APPEAL SUMMARY	
Status: Decision Rendered	
Appeal ID: 27656	Project Address: 2027 SE 174th Ave
Hearing Date: 4/13/22	Appellant Name: Mildred White
Case No.: B-001	Appellant Phone: 503-253-4283
Appeal Type: Building	Plans Examiner/Inspector: Renay Radtke Butts
Project Type: commercial	Stories: 2 Occupancy: SR-1 Construction Type: V-A
Building/Business Name:	Fire Sprinklers: Yes - throughout entire building
Appeal Involves: Alteration of an existing structure	LUR or Permit Application No.: 20-106889-CO
Plan Submitted Option: pdf [File 1] [File 2] [File 3] [I 4]	File Proposed use: exterior deck at care facility

APPEAL INFORMATION SHEET

A1.1 ENLARGED PROPOSED DECK PLANS

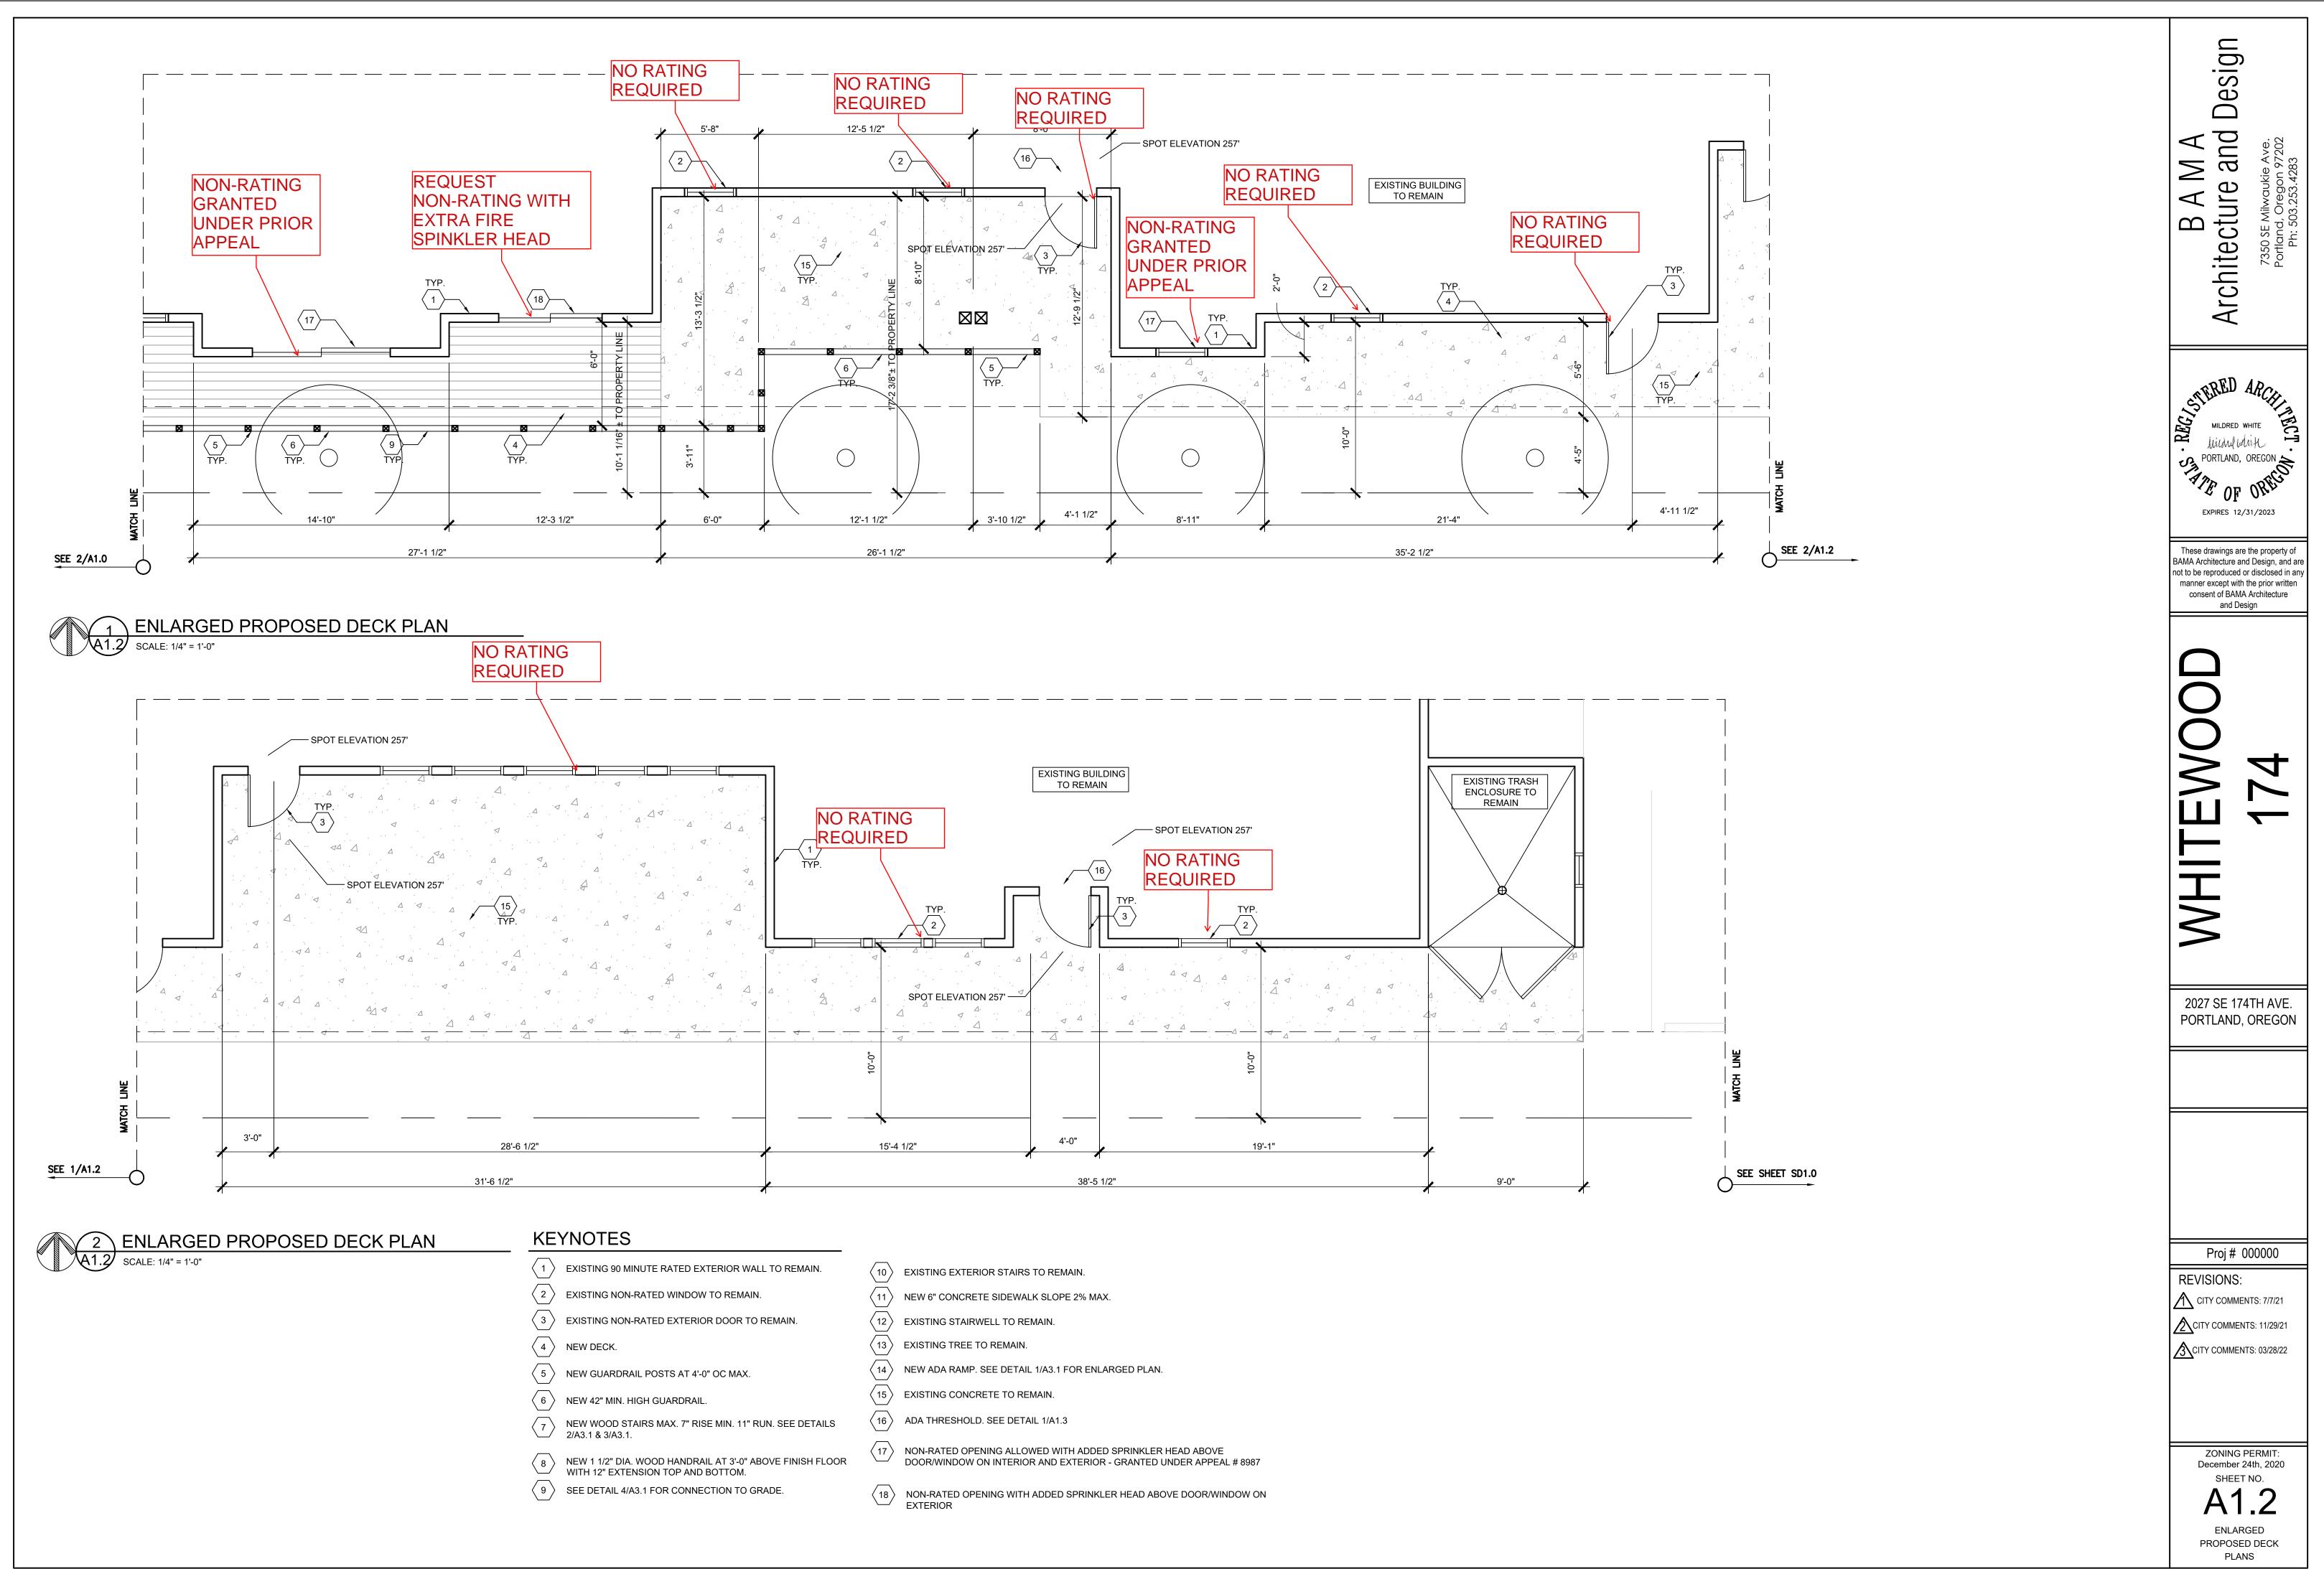
Code Section	1028.4.2
Requires	Where an egress court serving a building or portion thereof is less than 10 feet in width, the egress court walls shall have not less than 1-hour fire-resistance-rated construction for a distance of 10 feet above the floor of the egress court. Openings within such walls such be protected by openings having a fire protection rating of not less than 3/4 hour.
Code Modification or Alternate Requested	The request is to eliminate the 3/4 rating outright in areas where there is over 35' from building to property line, and request to eliminate the 3/4 rating in areas where there is smaller distance between building and property line. Please note, the elimination of the fire rating requirement for a number of openings were already approved under a previous appeal which is noted on the drawings.
Proposed Design	The elimination of the fire rating requirement for a number of openings was granted under an appeal submitted with the original building permit. This permit is only to legalize decks that were constructed and inspected with that permit, but never included under the permit scope. The decks were built because the original architect failed to note that the existing grade would not permit accessible use of the exterior doors in each resident's room. These raised decks were built within the building setback, decreasing the width of the egress courts. The existing openings which would require 3/4 rating are vinyl and operable. The windows could be replaced, but most are required to be operable for egress. The building is Type V-A construction, so all exterior walls are one-hour rated. Exterior fire sprinklers are installed along the perimeter of the building. We are requesting the non-rated windows to be permitted to remain with the installation of additional exterior fire sprinkler heads at locations where the distance between the building and property lines is 10'. At the rear, we are requesting no additional sprinkler heads be required since the distance between the building and property line is over 35'.

Reason for alternative The alternate is required in order to maintain the required egress windows. The purpose of the egress court is to provide safe passage. This will be provided with the combination of the Type V-A construction, fire sprinklers on the exterior along the path of egress (above the deck), and additional heads at locations where the distance is less than 35' to the property line. At these locations, the width of the deck is no less than 6', with an additional 4' to the property line. The window sizes are noted on the enlarged plans, varying from 1.5'x1.5' to 6.0'x5.0'. There are five exterior exit doors that do not utilize the egress court to reach the public way. There are three exit doors that utilize the egress court, along with two secondary exit stairs from the second floor.

Type 13 water curtain sprinkler protection at non-fire rated door and window openings in North, West and South exterior walls along egress court created by deck installation that is less than 10 feet in width: Granted provided doors are equipped with closers, sprinklers are spaced not more than 6 feet apart and placed a minimum of 6 inches and a maximum of 12 inches from the opening(s) and a maximum of 12 inches below the ceiling. Sprinklers are to be installed on the interior and exterior side of the openings. A separate permit from the Fire Marshal's Office is required.

Note: Fire damper protection of mechanical vent openings may be prescriptively used but no dryer vents PTAC units or eave vents may be located within appeal area..
